RICHMOND COMMUNITY SCHOOL
Richmond High School: Mechanical Modernization Project
LWC Commission No. 20104.02

ADDENDUM #04
October 5, 2021

| TOD | A901 |

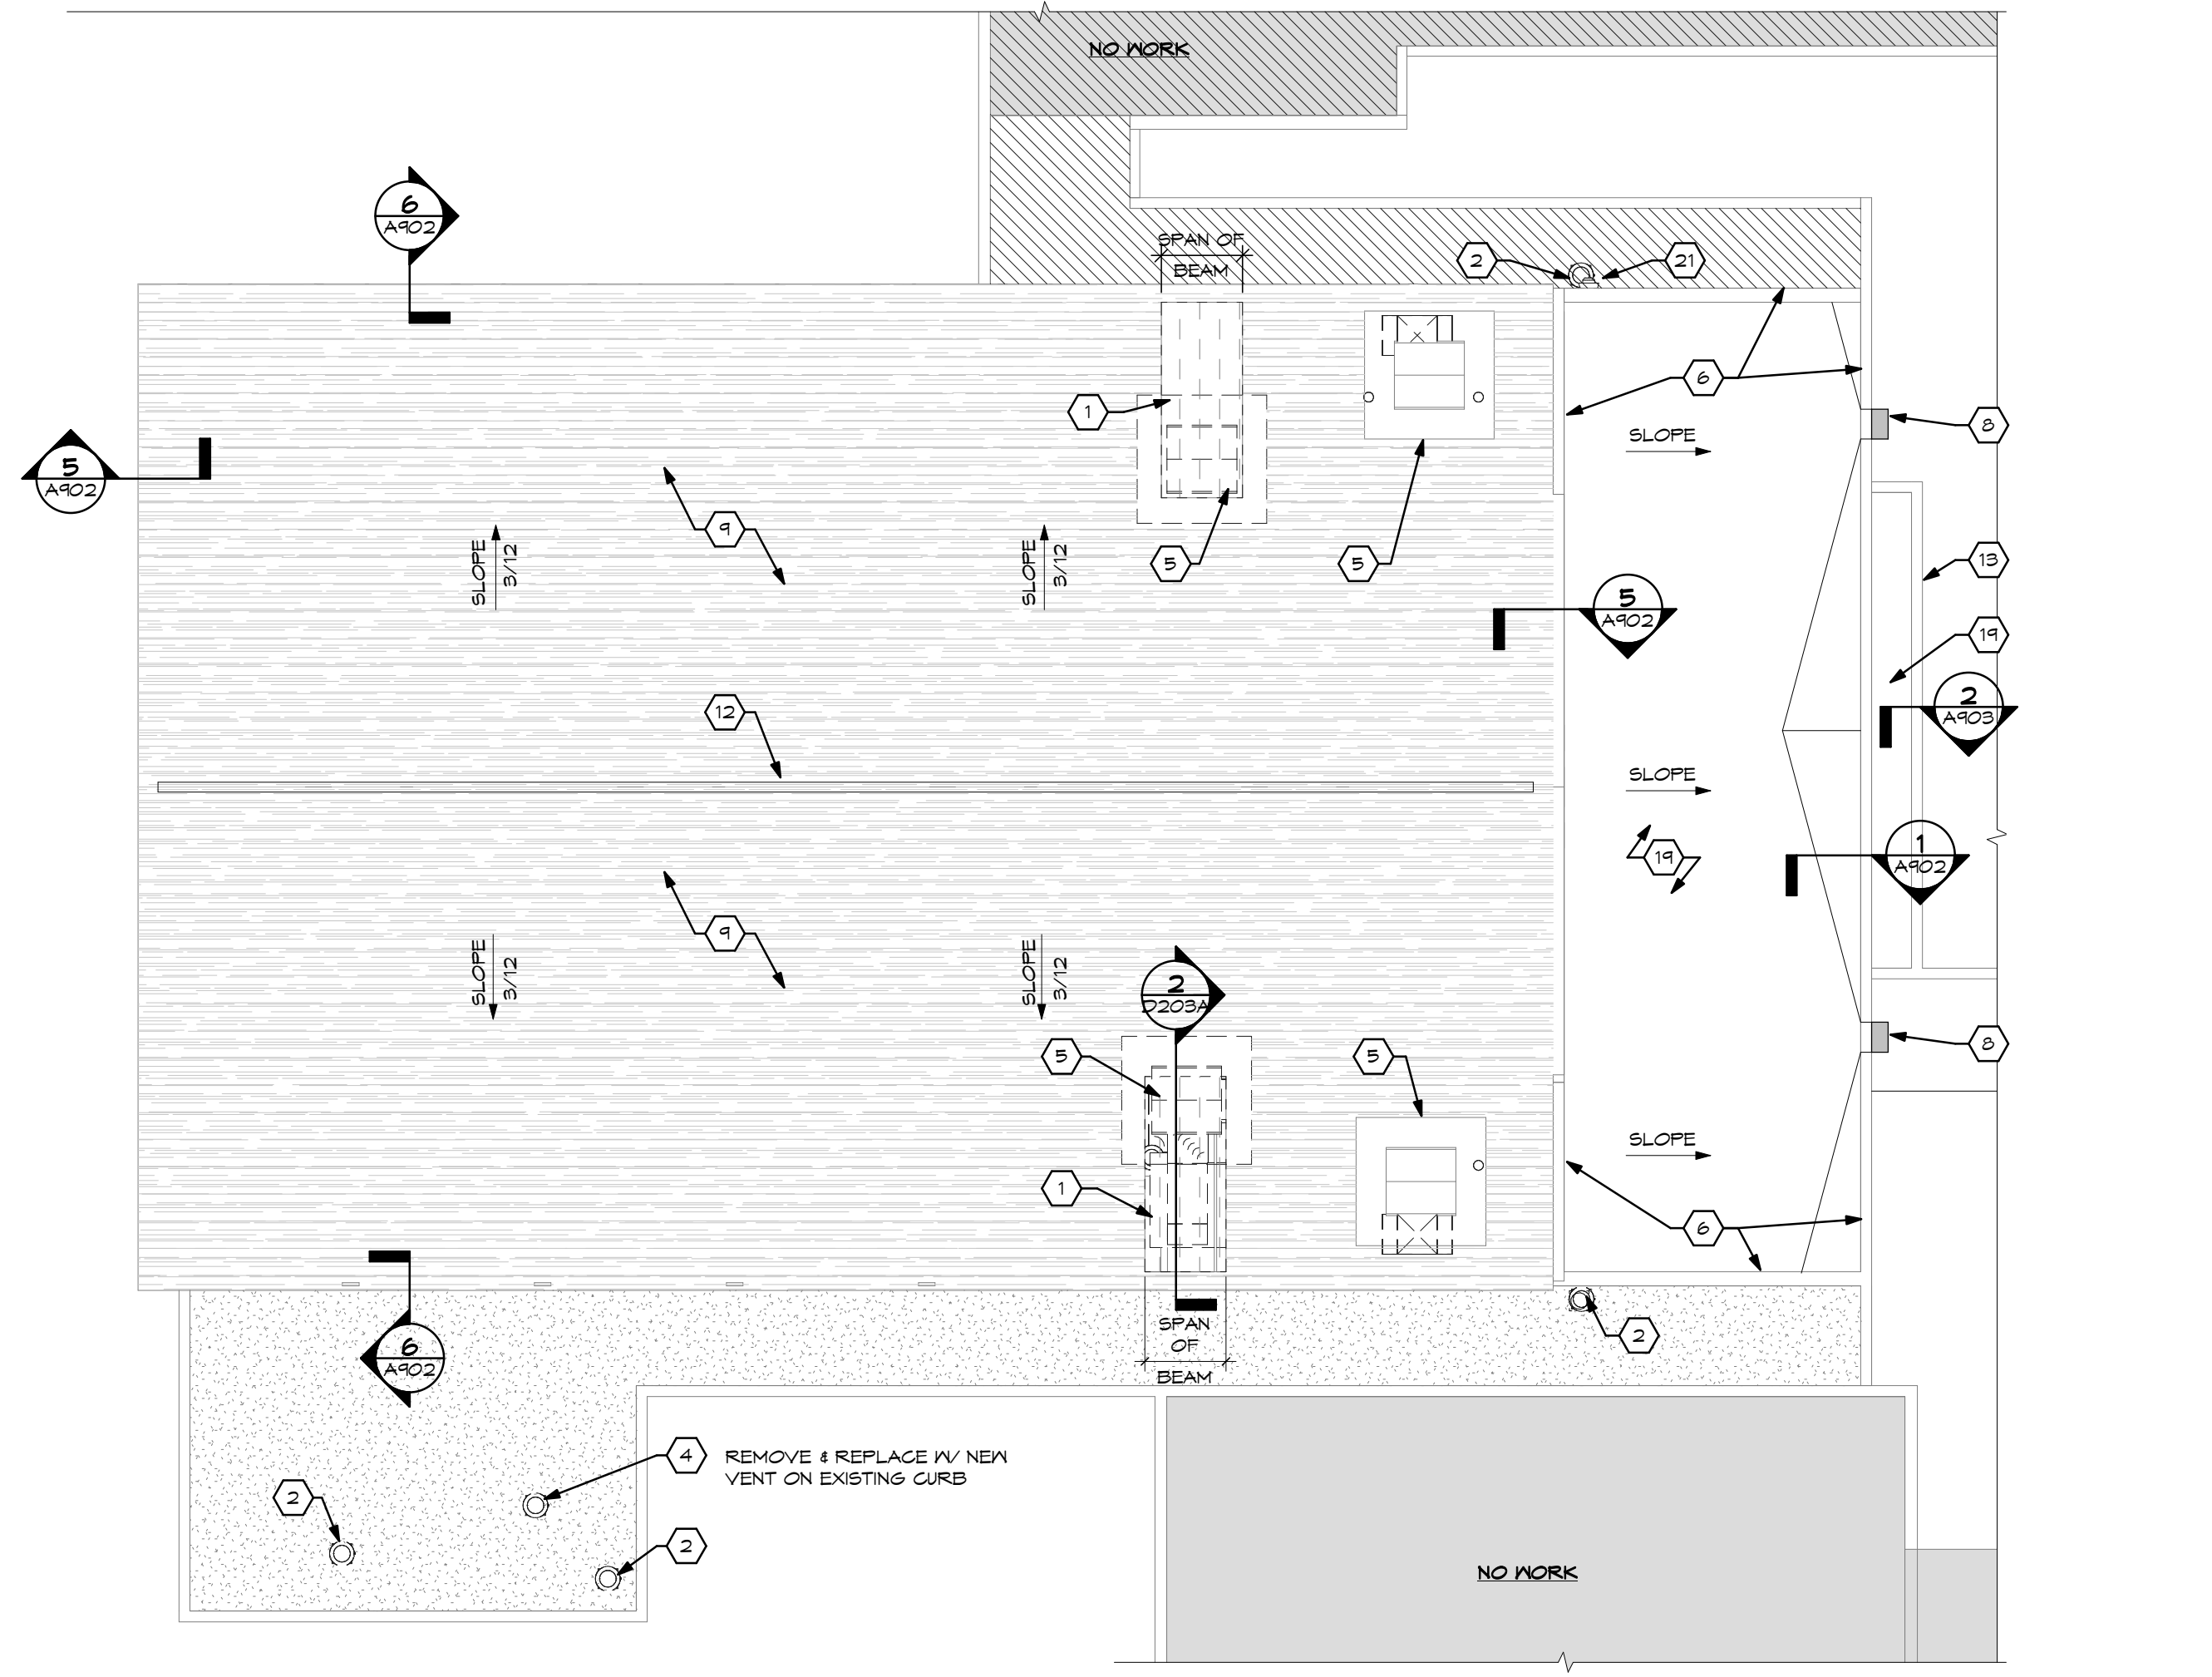
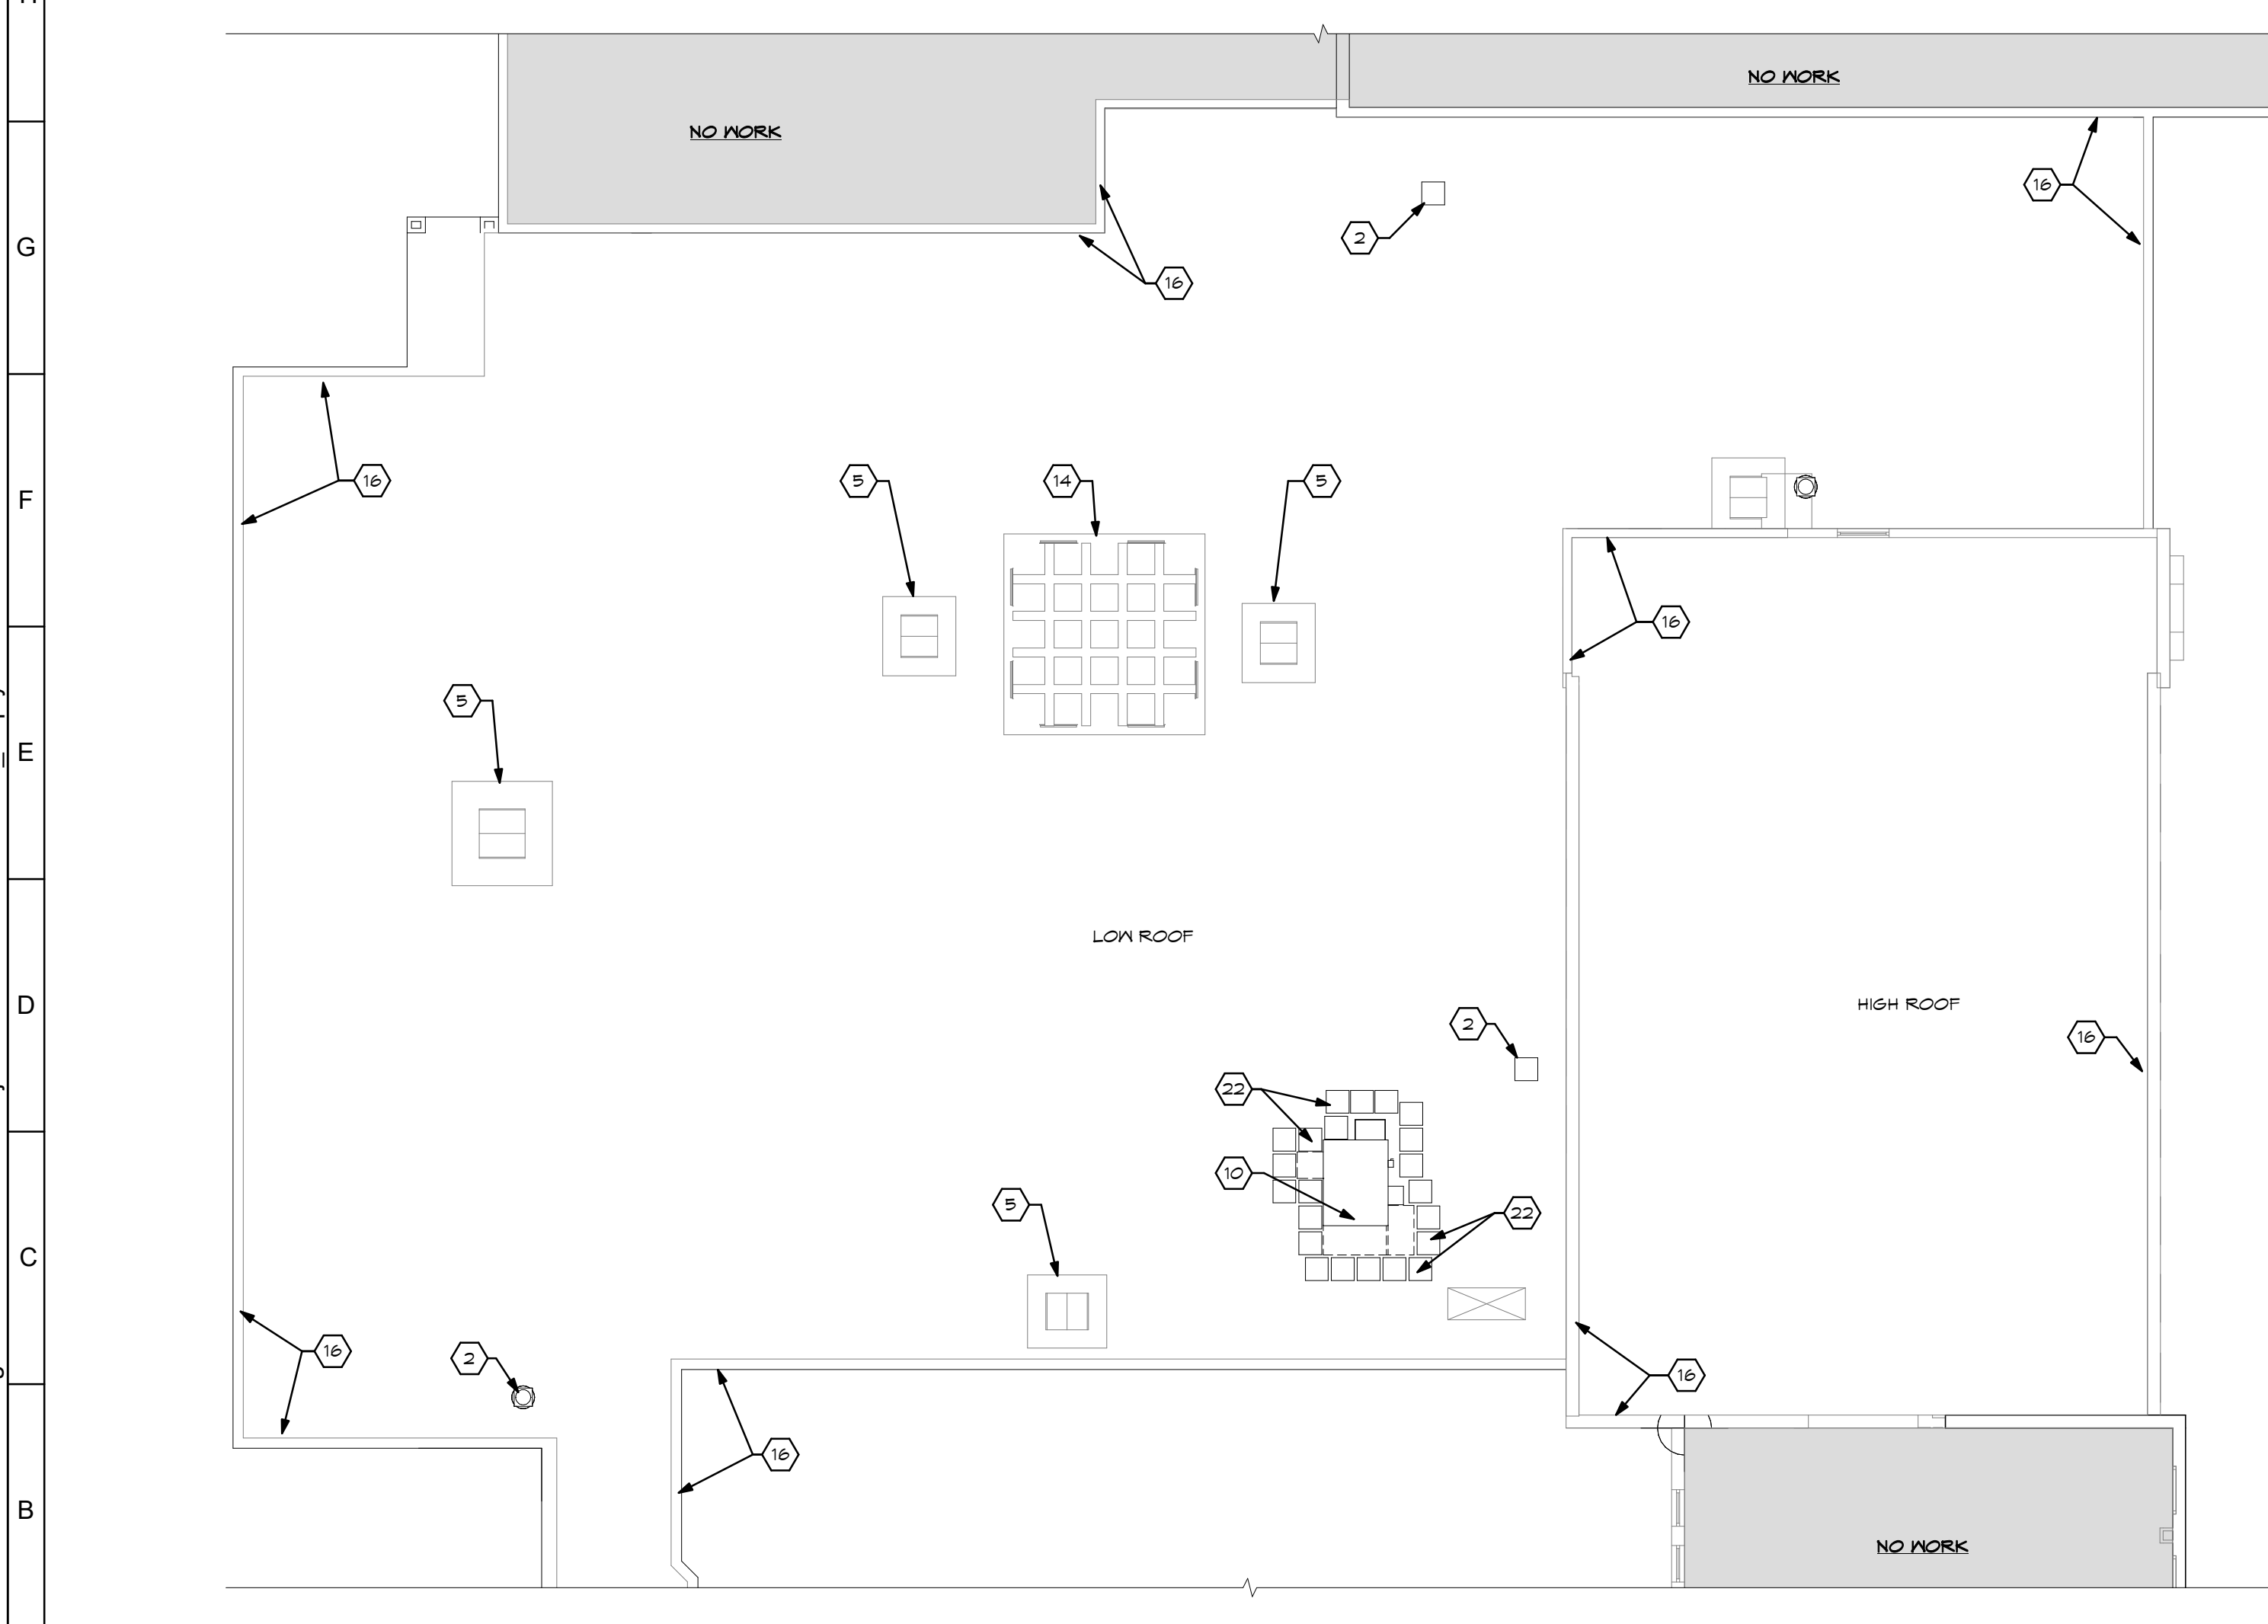
ITEM NO.4 Drawing A901

- A. Revised sheet note #13
- B. Added Sheet Note #22
